## **ADDENDUM #4**

**February 25, 2011**

Re: Harrisburg Area Community College  
Public Safety Center – Law Enforcement Complex & Site Improvements  
Solicitation # 11-13

From: Eastern PCM, LLC  
Construction Manager – HACC  
645 N. 12<sup>th</sup> Street, Suite 200  
Lemoyne, PA 17043

## CONSTRUCTION PARKING / LAYDOWN AREA

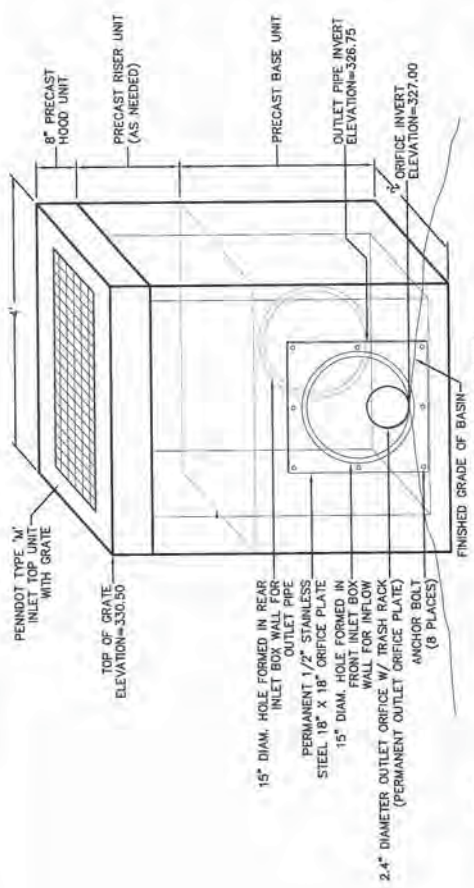
- A. Drawing C11: Add sketch SC-18 included in this addendum #4.
- B. Drawing C13: Add sketch SC-10 included in this addendum #4.
- C. Drawing C14: Add sketch SC-12 included in this addendum #4.
- D. Drawing C15: Add sketch SC-14 included in this addendum #4.
- E. Drawing C18: REVISE the size of the line from the water main in Industrial Road to the water meter pit to be 3-inch diameter.
- F. Drawing C28: Add sketch SC-16 included in this addendum #4.
- G. Drawing C29: DELETE wire mesh connection from curb to sidewalk on detail “on-site concrete curb and walk.”
- H. Drawing C32: Add sketch SC-9, SC-11, SC-13, SC-15, and SC-17 included in this addendum #4.

- A:** See Sketch SC-9 and SC-18.
- T. **Q:** Civil Drawing 18 Water service: The city will only tap the main and will not run line to meter vault per spec 02510-7, 3.4.13. The yearly costs to HACC for an 8" diameter service is \$19,661.00 whether they use 1 gal or 1000 gal. The size of a vault for an 8" meter with backflow preventer is 18' long. A 3" diameter lateral for a fire hydrant will not allow enough flow through the hydrant, it needs to be 6" diameter.

**STORMWATER MANAGEMENT BASIN  
 PERMANENT OUTLET STRUCTURE - OS-20 - BASIN 3**  
 NOT TO SCALE

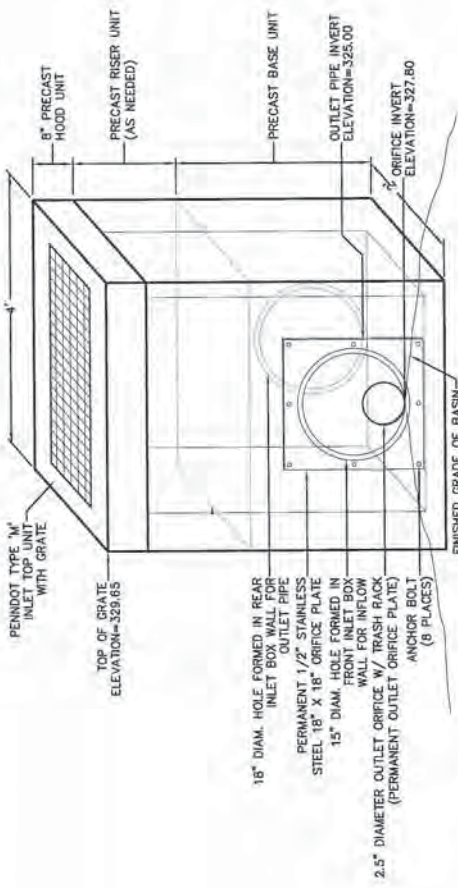
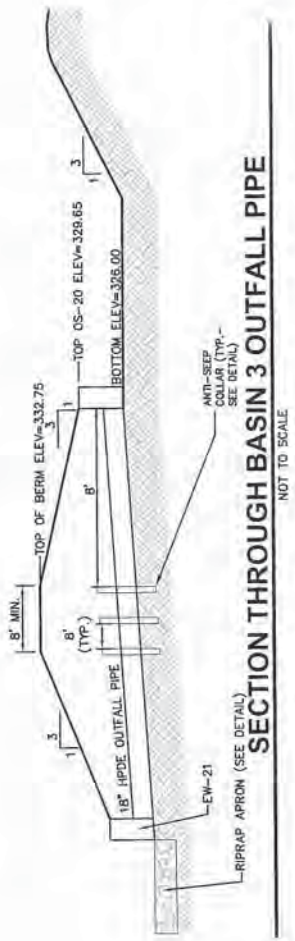
APPENDUM NOTES:  
 1. MODIFIED BASIN OUTLET STRUCTURE.

SCALE: AS SHOWN  
DATE: FEB. 24, 2011  
K&W PROJECT: 2091.001  
DRAWN BY: ROE  
CAD DRAWING: 2091001-I\_cadd115.dwg  
SHEET: SC-15

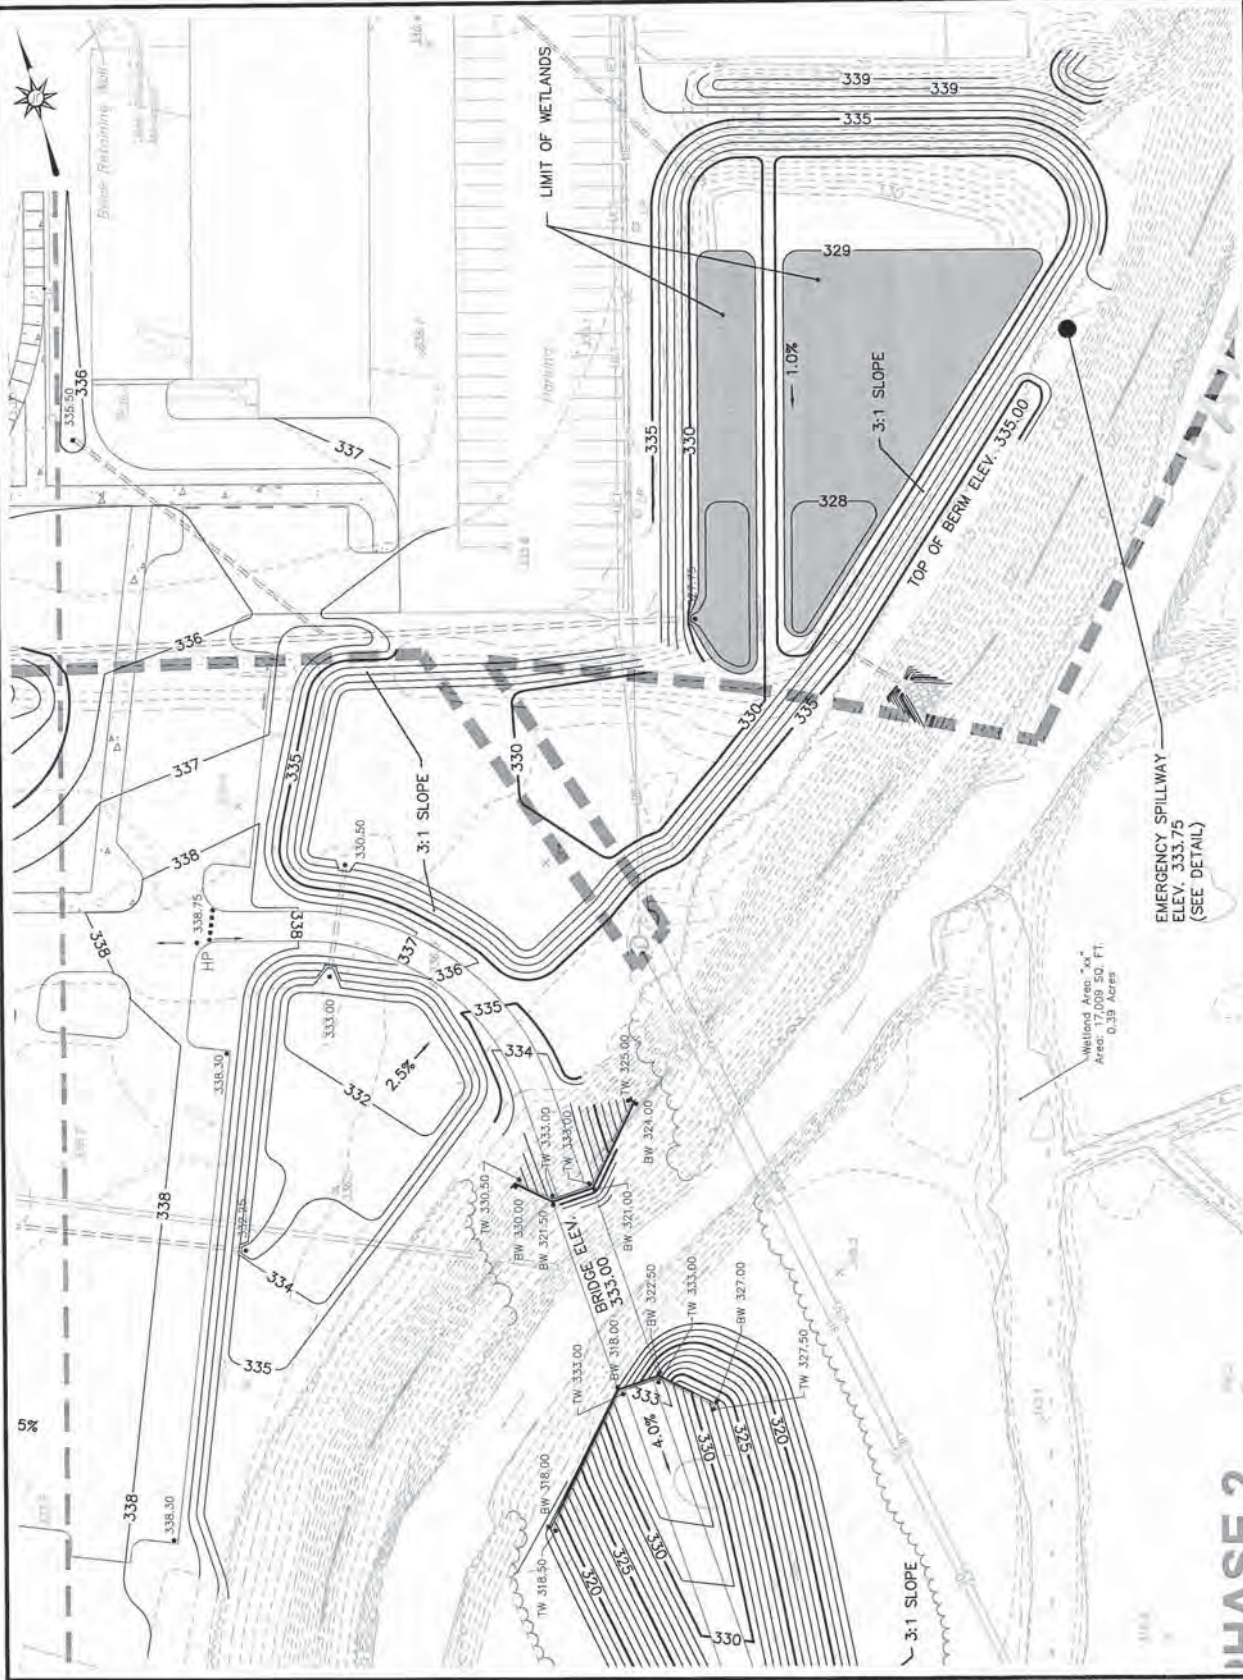
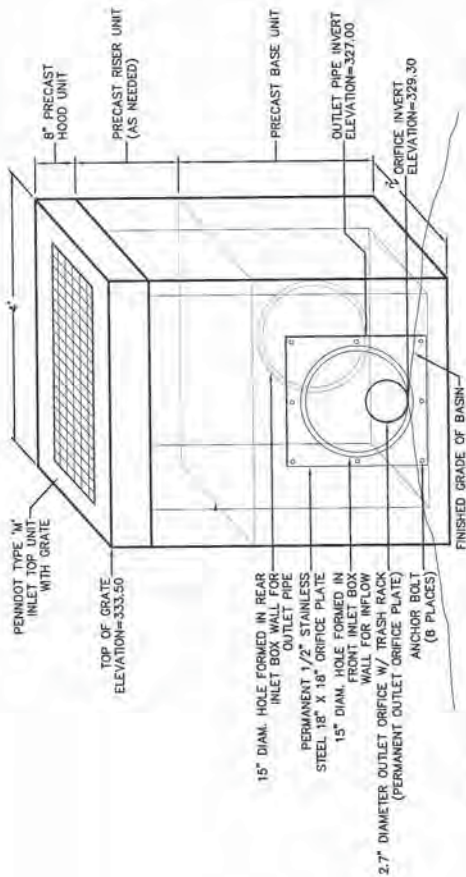
APPENDUM NOTES:  
 1. MODIFIED DETENTION BASIN DIMENSIONS  
 2. ADDED WETLAND  
 3. SHORTEN RIPRAP LENGTH WITHIN BASIN

**CONFINED SPACE / TRENCH  
ELEVATION/LAYOUT PLAN**

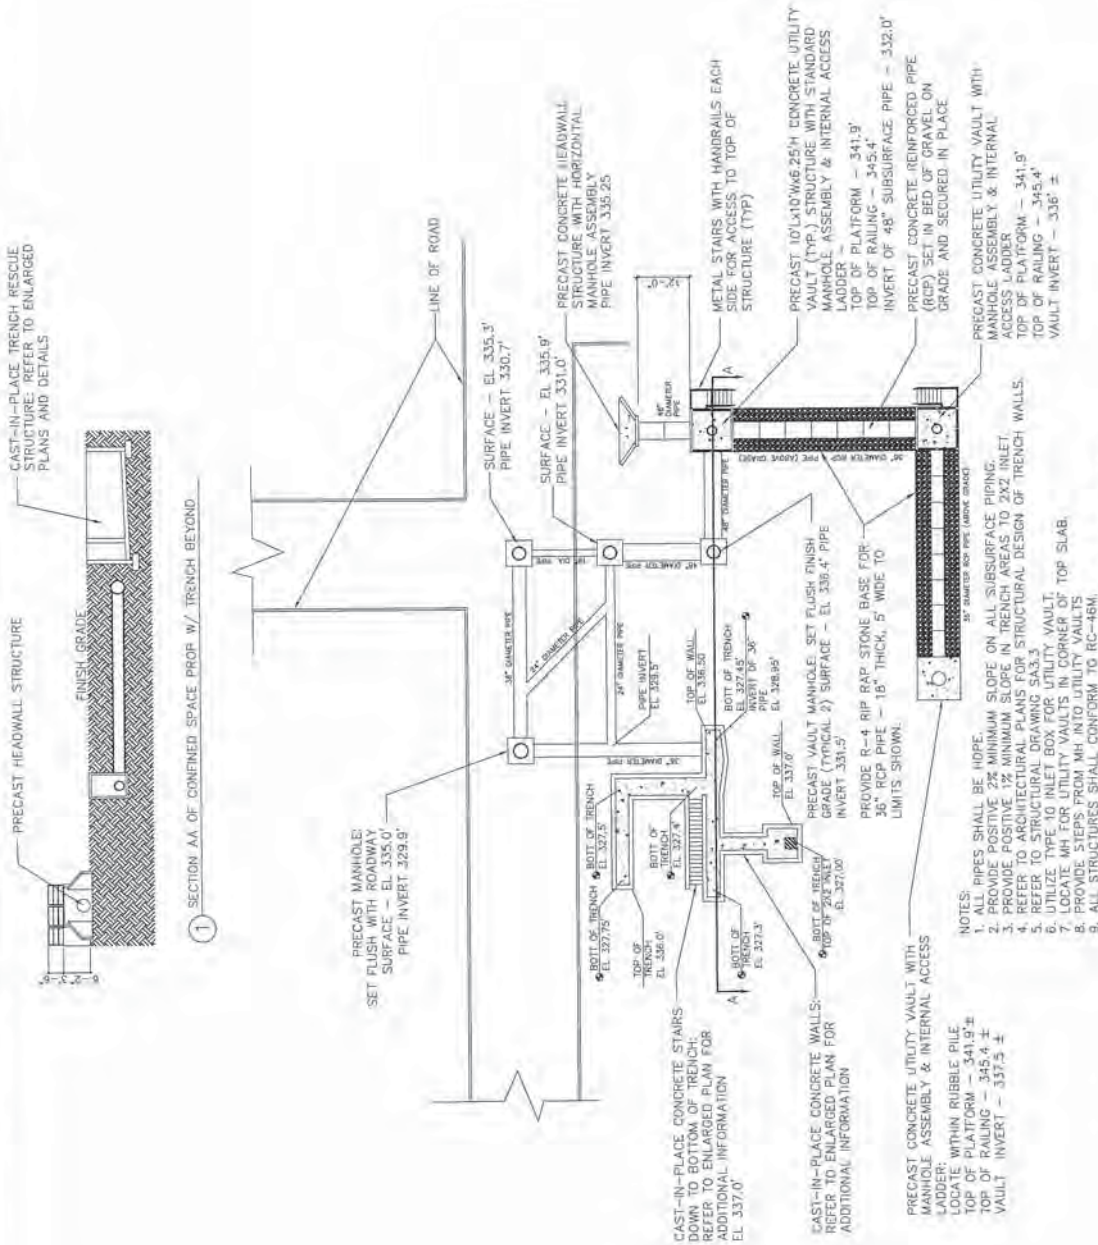
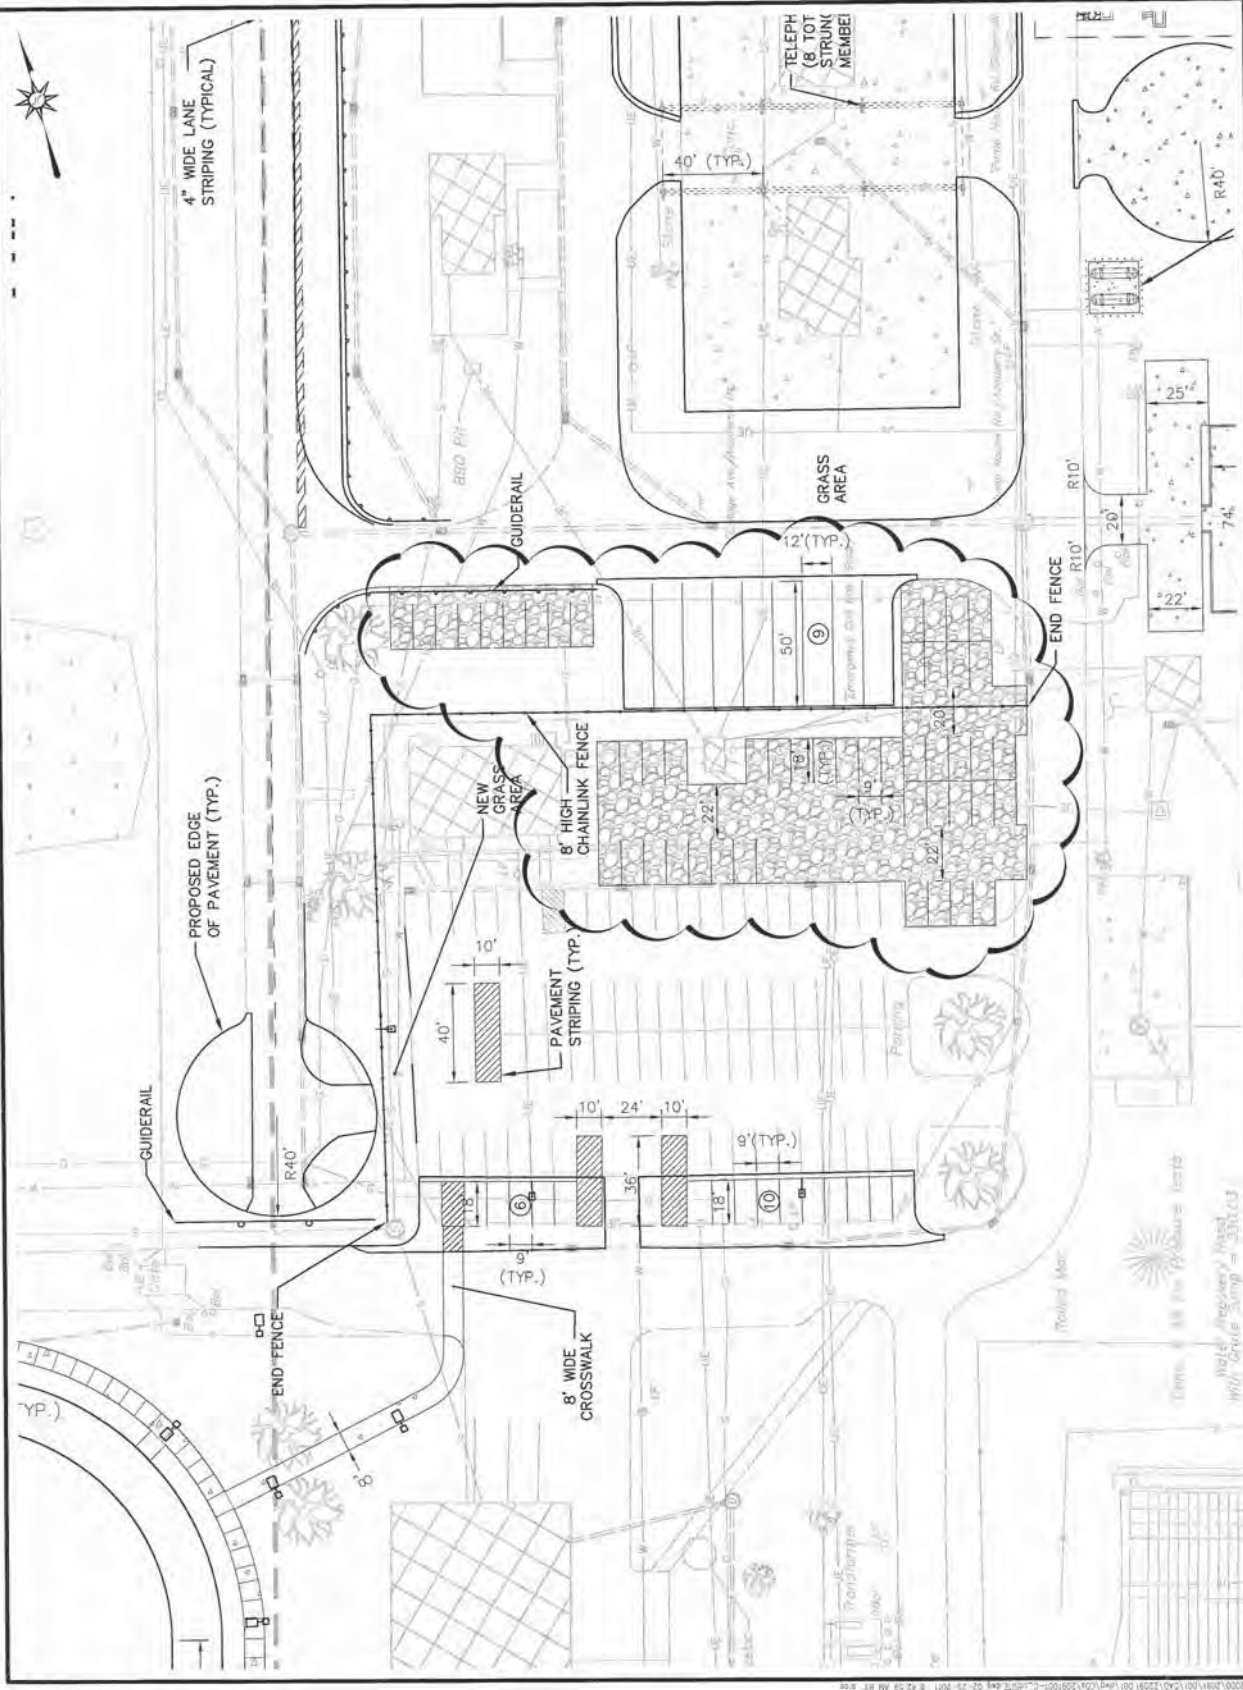
- A:** Provide bollards as shown on Sheet 11.
- EEEE. **Q:** Please provide more details on the confined space prop. Clarify where the removable railings are needed. Clarify if metal grate is required over all exposed trench and what kind. Provide more details on the metal stairs and railings shown.

APPENDUM NOTES:  
1. REVISED DETAIL

- A:** See Sketch -17 for revised detail.
- FFFF. **Q:** Civil Drawing 36 – Pedestrian Bridge – Is there any reinforcing in the bridge deck?

**23**  
MA5.2  
**DUCT ROOF PENETRATION AND SUPPORT DETAIL**  
NO SCALE

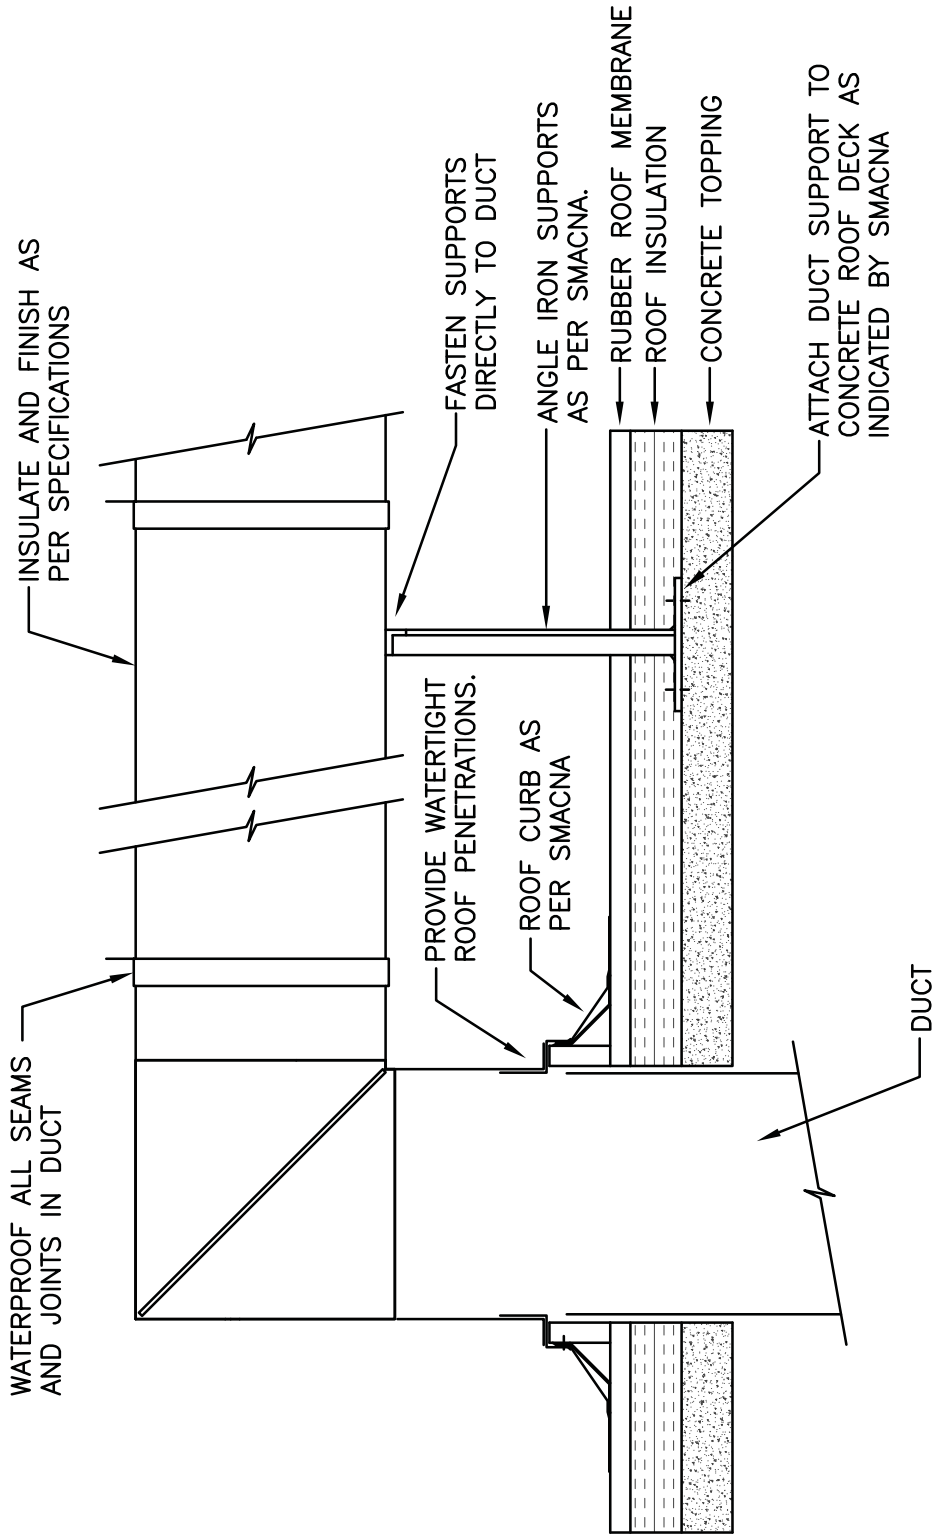
- W. Drawing MA5.2: ADD Detail #23 – duct roof penetration and support detail sketch SK-MA5.2-1, attached to this addendum #4.
- X. Drawing PA5.2: CLARIFICATION: On Detail 7 Vent Thru Roof, it is acceptable to use rubber flashing compatible with the roofing system in lieu of lead shown.

- A:** EMT is acceptable in the firing range.
- EE. **Q:** Is there a Detail to how to support the roof duct?
- A:** SK-MA5.2-1 is applicable for all roof duct supports.

# PROJECTION SCREEN WIRING DIAGRAM (TYP)

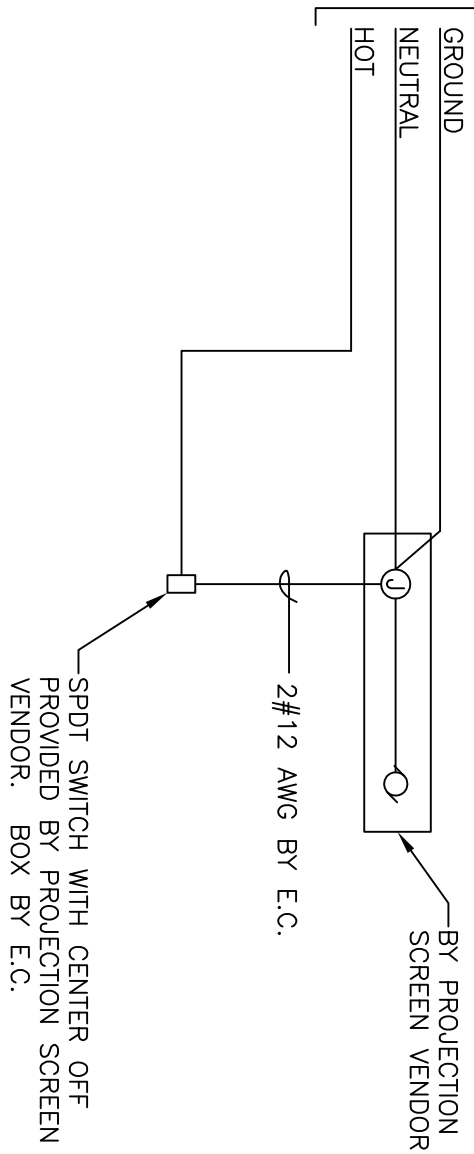
- BB. Drawing EA5.4:
- a. ADD projection screen wiring diagram sketch SK-EA5.4-1, attached to this addendum #4.
